## **LABRADOR RUN SUBDIVISION,** **PHASE THREE A**

APPLICATION NUMBER 6 DATE December 19, 2013

REQUEST Subdivision

# DETAIL SITE PLAN

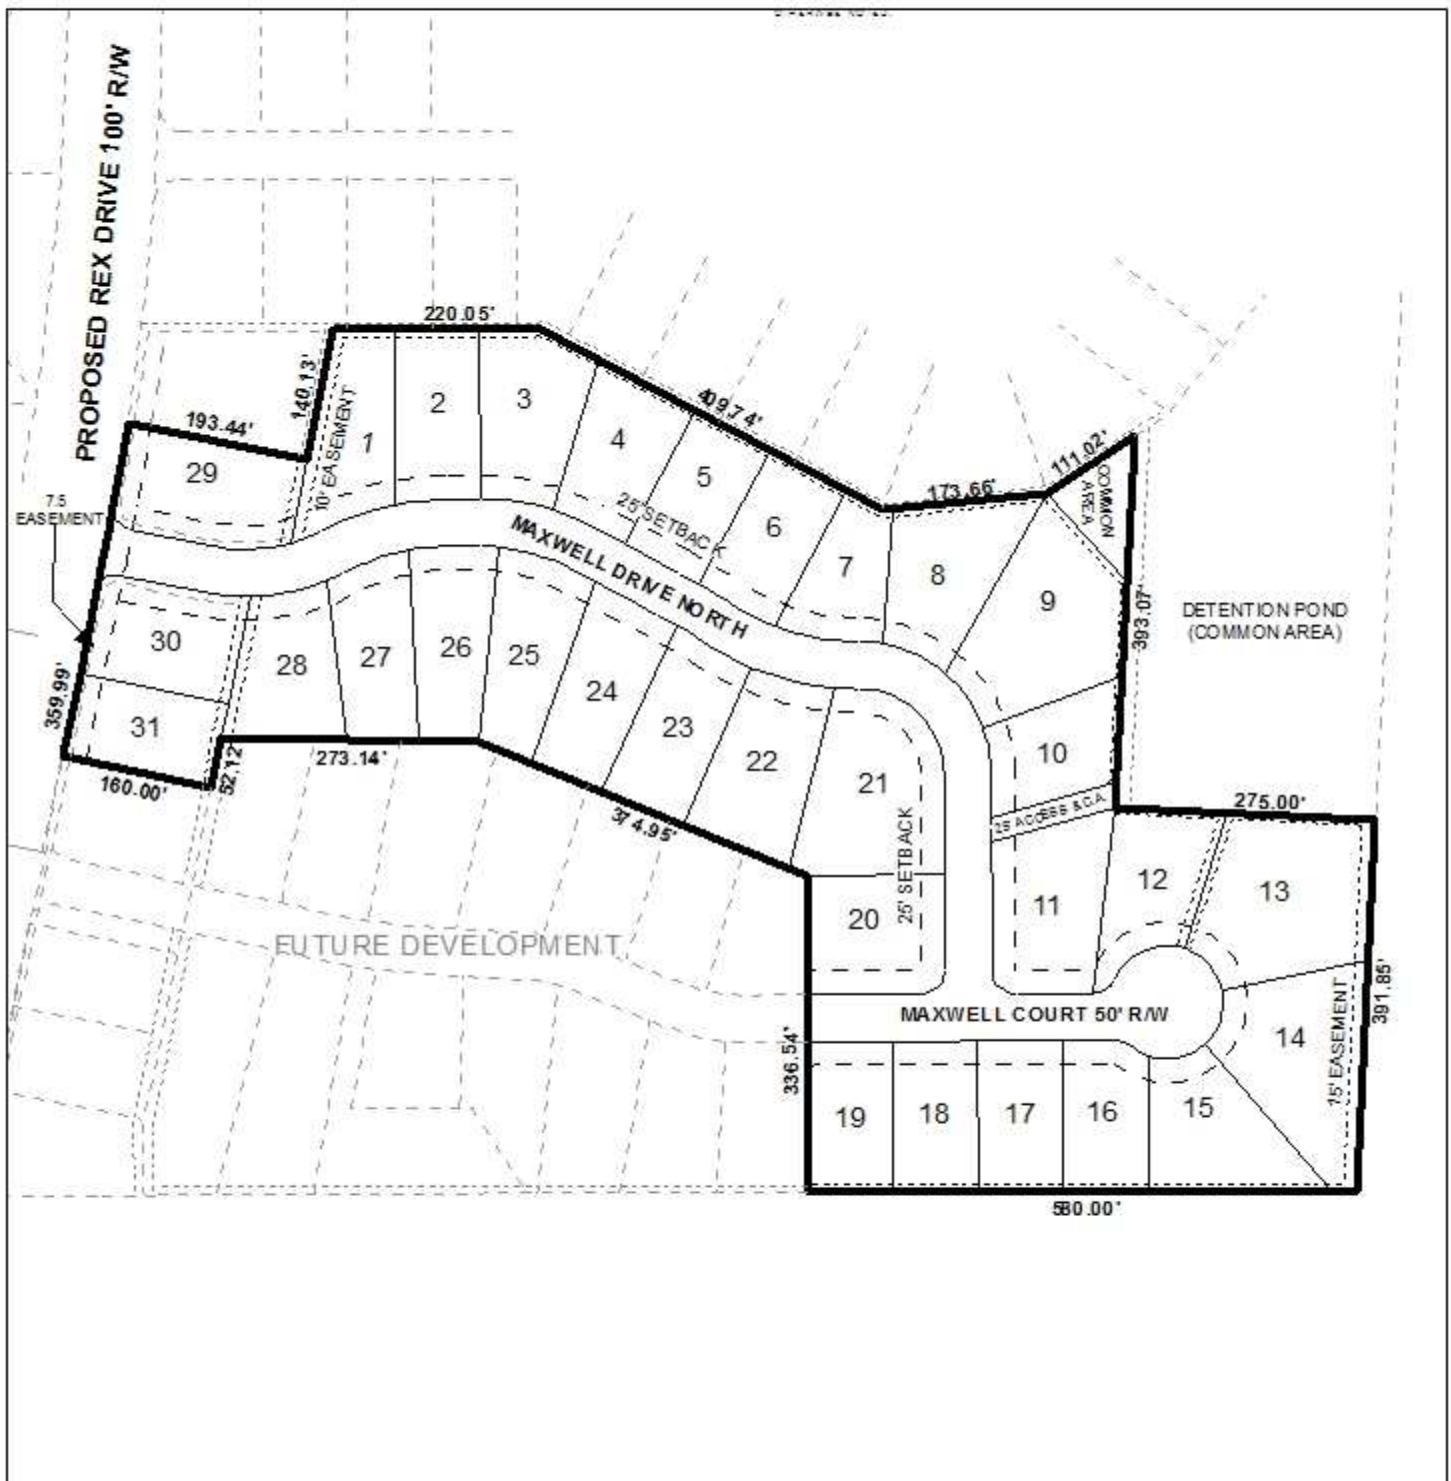
The preliminary plat illustrates the construction of two new streets labeled as Maxwell Drive North and Maxwell Court. It should be pointed out that Maxwell Court terminates as a street stub in an area labeled as "Future Development." If approved, a provision of a (temporary) turnaround in compliance with Sections V.B.6. and V.B.14. of the Subdivision Regulations should be illustrated on the Final Plat at the terminus of Maxwell Court, if required by Mobile County Engineering.

It should be pointed out that the site contains numerous easements which are illustrated on the preliminary plat. If approved, a note should be placed on the Final Plat stating that no permanent structures can be constructed in any easement.

It should also be noted that the site contains several common areas. The largest is labeled as a detention pond and is a portion of Phase One; however, it appears that access will be via a 25' access and common area through Phase Three A. A common area, to the rear of the proposed Lot 9 is also illustrated; however, no access is shown on the preliminary plat but because it abuts the

detention pond/common area, it could be assumed to be a portion of the larger common area. The preliminary plat also illustrates notes in reference to maintenance of the common areas and those notes should be retained on the Final Plat, if approved.

All proposed lots appear to meet the minimum size requirements; however, the lot size in square feet and acres is not illustrated on the preliminary plat but should be depicted for all lots on the Final Plat, if approved.

A note on the preliminary plat reads, "*Lots 1 & XX are denied direct access to Rex Drive and all lots are limited to a single curb-cut each with the size, design and location to be approved by Mobile County Engineering.*" As a means of access management, the note should be revised to list the correct lots which are to be denied direct access to Rex Drive and the rest of the note should also be revised on the Final Plat to limit all proposed lots to one curb-cut, with the size, design and location to be approved by Mobile County Engineering and conform to AASHTO standards.

There appears to be a discrepancy within the legal description and the bearings depicted on the preliminary plat for the rear lot line of the proposed Lots 21-25. The plat depicts S67°56'18"E when the legal descriptions reads N67°56'18"W. This discrepancy should be corrected on the Final Plat, if approved.

This application is recommended for Holdover until the January 16, 2014 meeting with revisions due by January 9, 2014 to address the following:

- 1) Submission of an overall site layout for the entire remaining area of the proposed Labrador Run Subdivision.
